CASE 2022-2839-ZC
HONEYBEE HOLDINGS, LLC
TND-2 SEEKING PLANNED TRADITIONAL
NEIGHBORHOOD DEVELOPMENT

ZONING STAFF REPORT
2022-2839-ZC

Honeybee Subdivision
TND-2 General Implementation Plan
Lacombe, Louisiana
DDG #20-889

HONEY BEE SUBDIVISION **FIGURE 2**

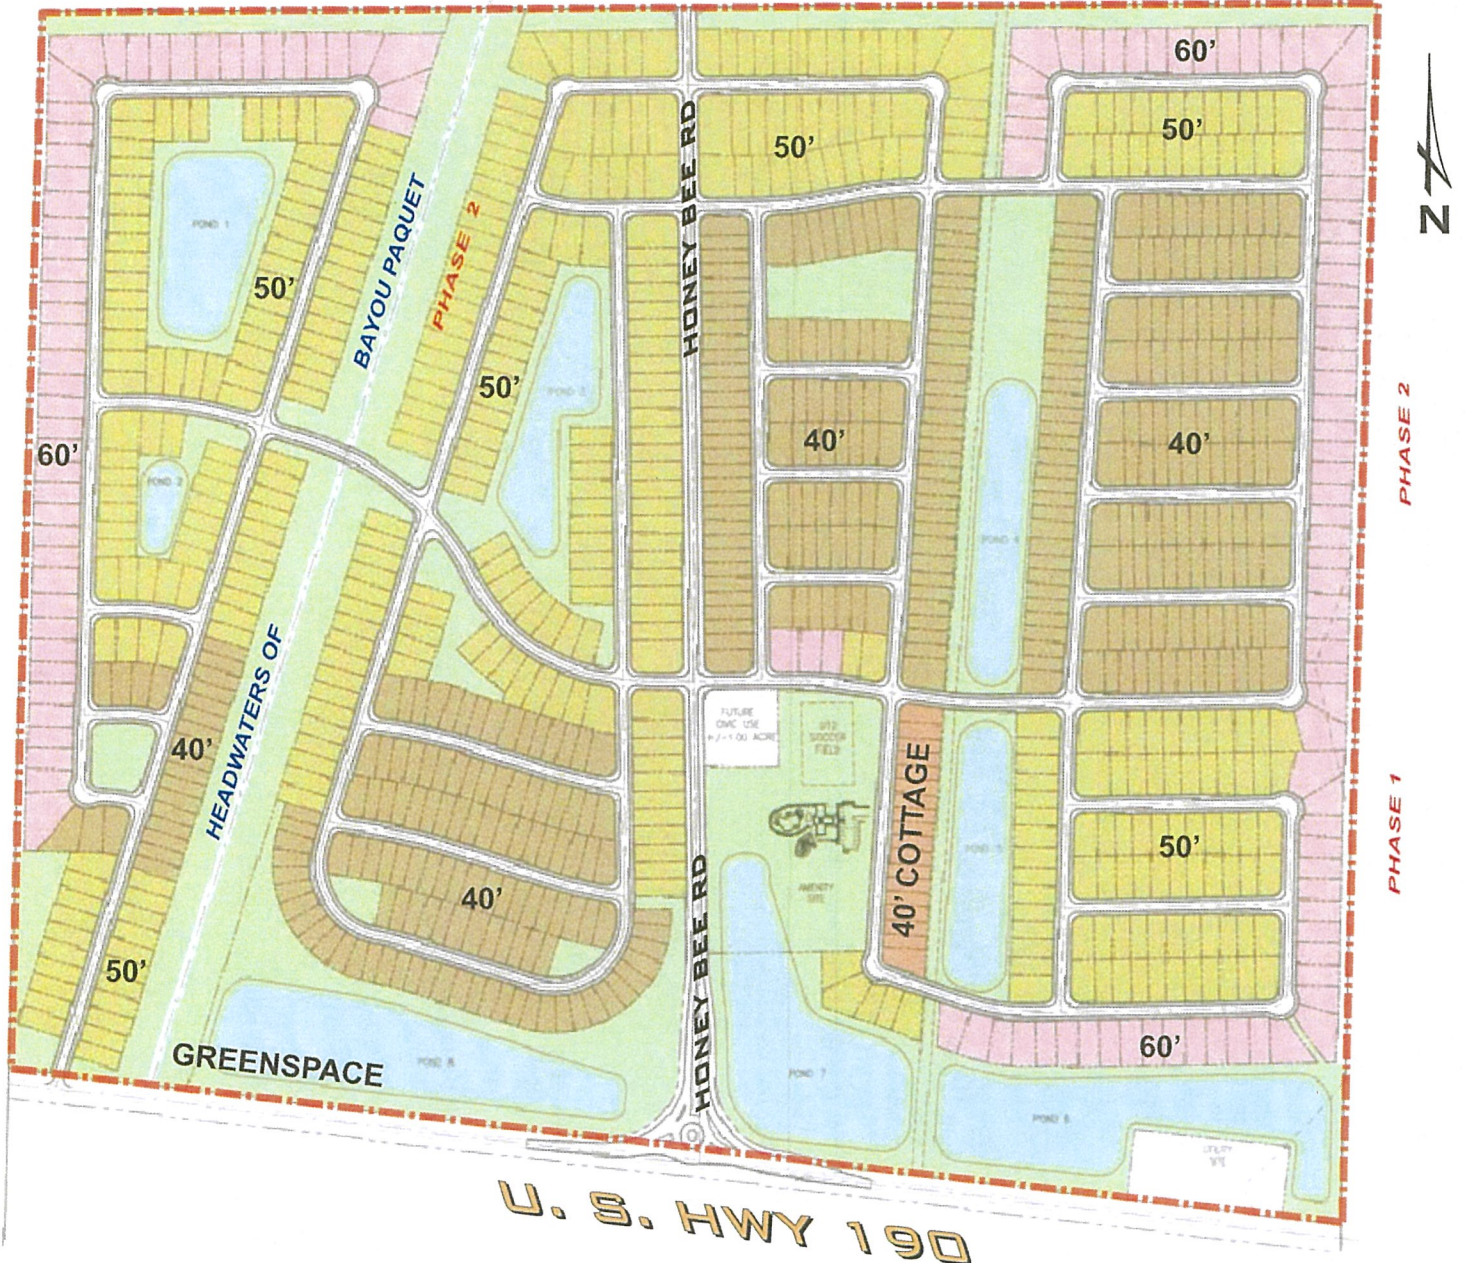
The ponds, density and residential type shown in Figures 2 and 2A of the Corps application, are not consistent with the applications submitted to St. Tammany Parish Department of Planning & Development (STP P&D). Specifically, STP P&D has never seen a document that denotes assumed lot lines like Figures 2 and 2A. The most recent version of the TND2 development was submitted to STP P&D on June 24, 2022 showing 1,575 residences (788 single-family and 785 multi-family) with 10,000 ft² commercial/civic use and some greenspaces.

- The Parish requests that the Corps communicate with the permit applicant and the STP P&D to ensure that the most current plans are provided and impacted wetlands are appropriately calculated.

Figure 2 in the Corps permit application shows multiple outfalls from stormwater detention ponds discharging into the north side of US Hwy 190 roadside ditch, which then discharges under US Hwy 190 into Bayou Paquet. The preliminary hydrology study submitted to STP Department of Engineering (April 8, 2021) shows a single outfall from the west side of the development under Hwy 190 into Bayou Paquet. Bayou Paquet south of Hwy 190 is designated as Flood Zone A and has a number of homes that are listed on FEMA's repetitive loss and severe repetitive loss (RL/SRL) list. Modeling of stormwater runoff with TR-55 assumes that 1/8 acre lots are estimated to be 65% impervious. At the proposed level of density in the development, there may be as much as 95% impervious surface in certain areas. The Parish is concerned that removal of the wetlands and bringing in fill will reduce the native hydraulic storage, may incur greater runoff from the impervious surfaces and exacerbate downstream flooding.

- The Parish requests that the Corps, when determining mitigation for this proposed development, require the developer to demonstrate that the mitigation of these wetlands elsewhere will not have an impact on the local hydrology.
- The developer has agreed to run a 2-D model that includes a 100-year and 500-year events to assure that homes located near the detention ponds and Bayou Paquet within the development will be adequately removed from inundation from potential flood sources, and that adequate sewer effluent drawdown will maintain the zero-discharge permit requirements of LDEQ.

SECTION C-C
BOX CULVERT - BAYOU PAQUET STREET CROSSING

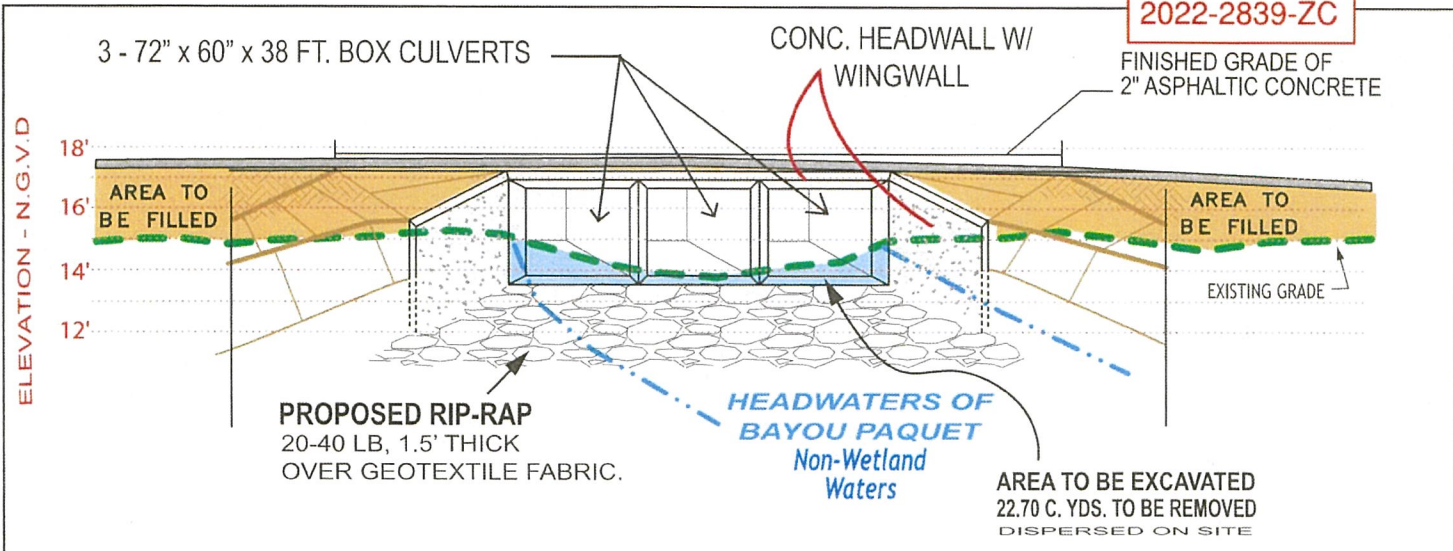
Excavation of Bayou Paquet. Figure 3A (Section C-C) of the Corps application shows excavation of Bayou Paquet, squaring the bottom to 13.5 ft elevation, and constructing 3 - 72" x 60" x 38 ft. box culverts, installing concrete headwalls with wingwalls, and 1.5 ft deep riprap over geotextile fabric. Fill will be added from the approximate 15 ft natural grade to 18 ft when including the asphalt overlay. This will require widening of Bayou Paquet from 12 ft to 18 ft in that location to accommodate the box culverts. Bayou Paquet downstream of the widening is not shown, but the Bayou at Hwy 190 has 3 existing 48" culverts.

- There are concerns that the discharge from the widened section must match the downstream capacity in order to avoid erosion or inundation.
